<b>Device</b>	<b>TC23x</b>
<b>Marking/Step</b>	<b>ES-AC, AC</b>
<b>Package</b>	<b>see Data Sheet</b>

## 10312AERRA

This Errata Sheet describes the deviations from the current user documentation.

**Figure 1 Message buffer transfer from Message RAM to OBF**

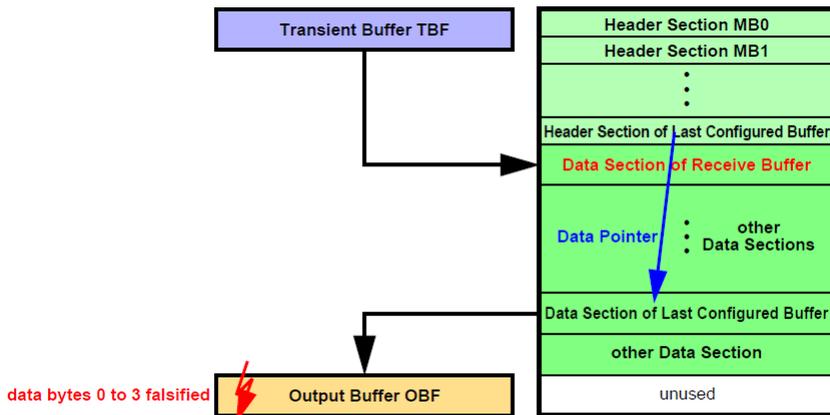
When the message buffer has its payload configured to maximum length (**PLC** = 127), the OBF word on address 00h (payload data bytes 0 to 3) is overwritten with unexpected data at the end of the transfer.

a) When a message is transferred from the Last Configured Buffer in the Message RAM to the OBF and **PLC** = 127 it may happen, that at the end of the transfer the OBF word on address 00h (payload data bytes 0 to 3) is overwritten with unexpected data (see [Figure 1](#)).

**Figure 2 Message buffer transfer from IBF to Message RAM**

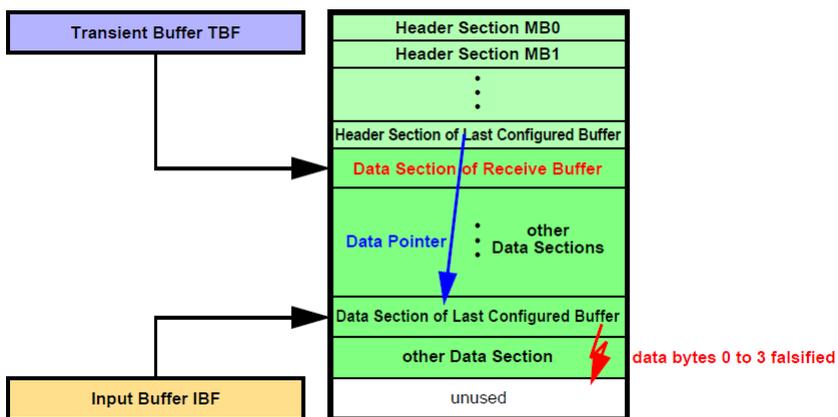
After the Data Section of the selected message buffer in the Message RAM has been written, one additional write access overwrites the following word in the Message RAM which might be the first word of the next Data Section.

b) When a message is transferred from IBF to the Last Configured Buffer in the Message RAM, it may happen, that at the end of the transfer of the Data Section one additional write access overwrites the following word, which may be the first word of another message's Data Section in the Message RAM (see [Figure 2](#)).

Figure 3 Message RAM Configurations

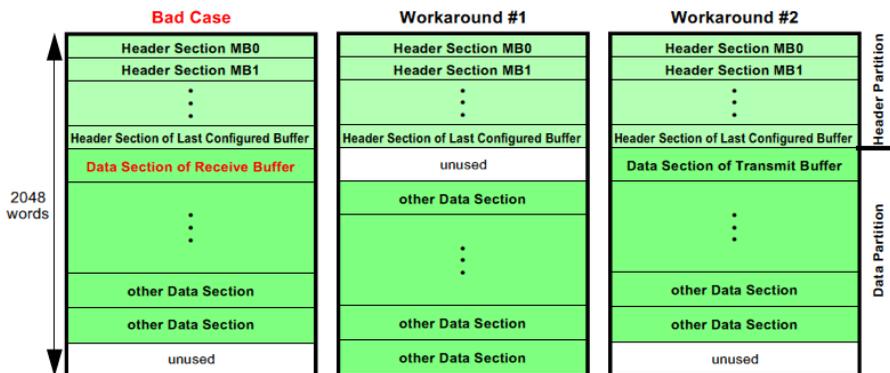
The erratum is limited to the case when (see [Figure 3](#) “Bad Case”):

2) Ensure that the Data Section directly following the Header Partition is assigned to a transmit buffer.

Figure 4 Transmitter - winning CAN FD node

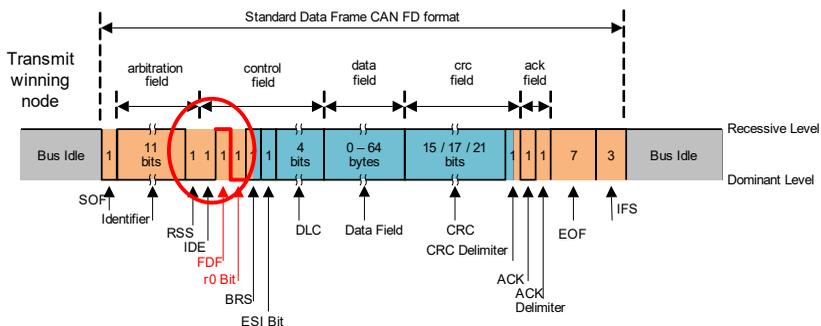
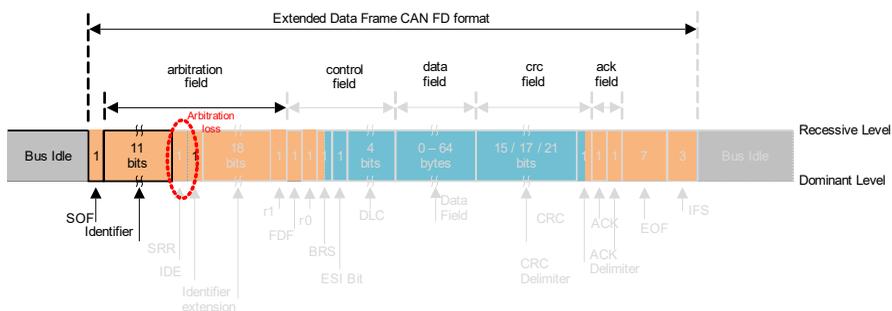
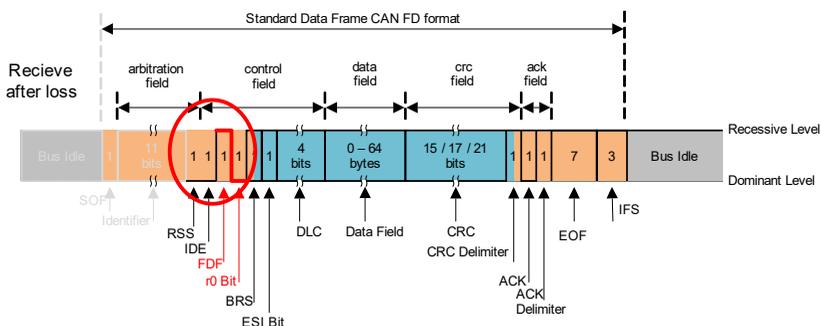
If a transmitter is losing arbitration late (e.g. in an extended frame - see [Figure 4](#) the node which wins arbitration and [Figure 5](#) the transmitting node losing arbitration), then the FDF bit to res bit is the last chance to synchronize to the winning node (here as a receiver [Figure 6](#) the same node as in [Figure 5](#)). A timing offset will occur between the now receiving node and the actual transmitter.

The device is producing more error frames within a network than a device with a hardsync at the FDF bit.

**Figure 12 Package Outlines TQFP-144 for TC23x**

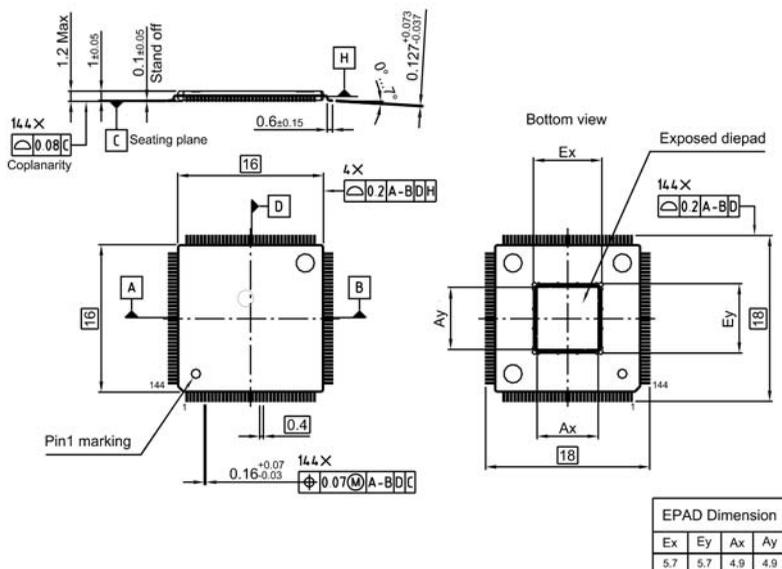
This information shall substitute the corresponding information in the TC23x AC-step Data Sheet V1.0 and in the TC23x A-step Data Sheet V1.1.

*Note: For the exposed pad of the TQFP-144 package of the TC23x, structural corner protrusions have to be considered for purposes of system design and integration with a maximum boundary of 6.2 mm.*

**Figure 13 Package Outlines TQFP-100 for TC23x**

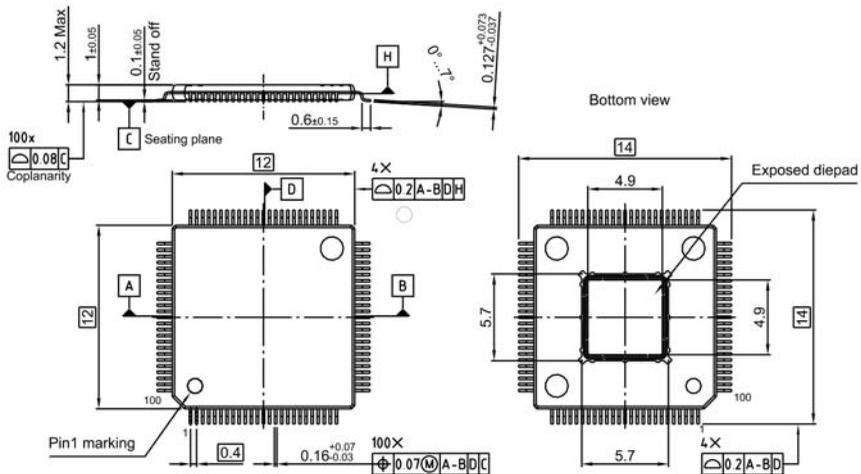
*Note: For the exposed pad of the TQFP-100 package of the TC23x, structural corner protrusions have to be considered for purposes of system design and integration with a maximum boundary of 6.3 mm.*

**Figure 14 Ripple Voltage vs. Frequency Characteristic**

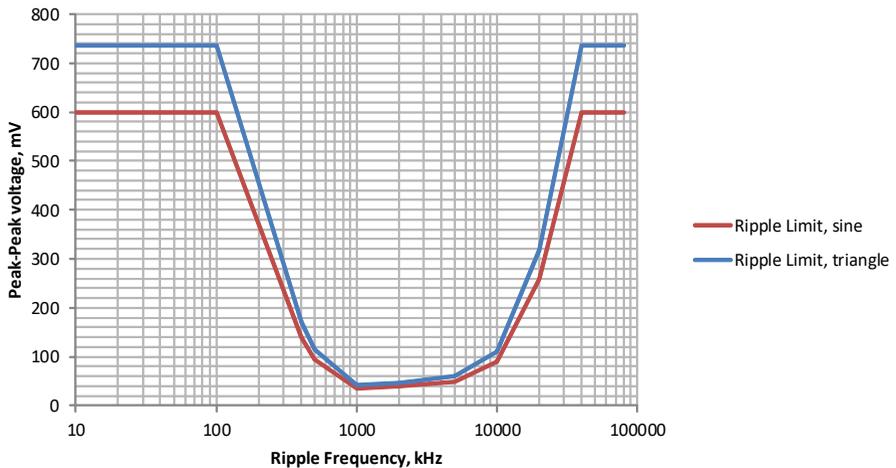
The internal back-up clock is sensitive to specific power supply voltage disturbance/ripple caused by a voltage ripple intrinsic to DC-DC converters. Specific conditions such as insufficient filtering of the ripple may lead to improper behavior of the start-up scheme of the back-up clock, and thus stuck-at state during the start-up of the microcontroller until this condition is removed.

The diagram reflects acceptable ripple level during the cold start of the microcontroller at the respective VDDP3/VEXT/VEVRSB supply of the PMS subsystem, depending on the device and package type, as shown in the following table.

**Figure 15 Short Serial Message, Serial Data Encoding over 16 messages**

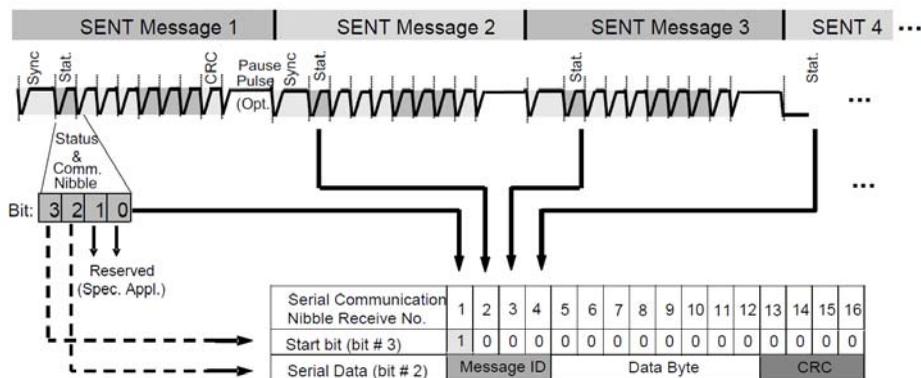
In Figure “Short Serial Message, Serial Data Encoding over 16 messages” of the SENT chapter, the arrows originating from bits 2 and 3 of the Status & Comm Nibble are routed incorrectly and must be swapped.

**Figure 15** shows a corrected version of this figure.
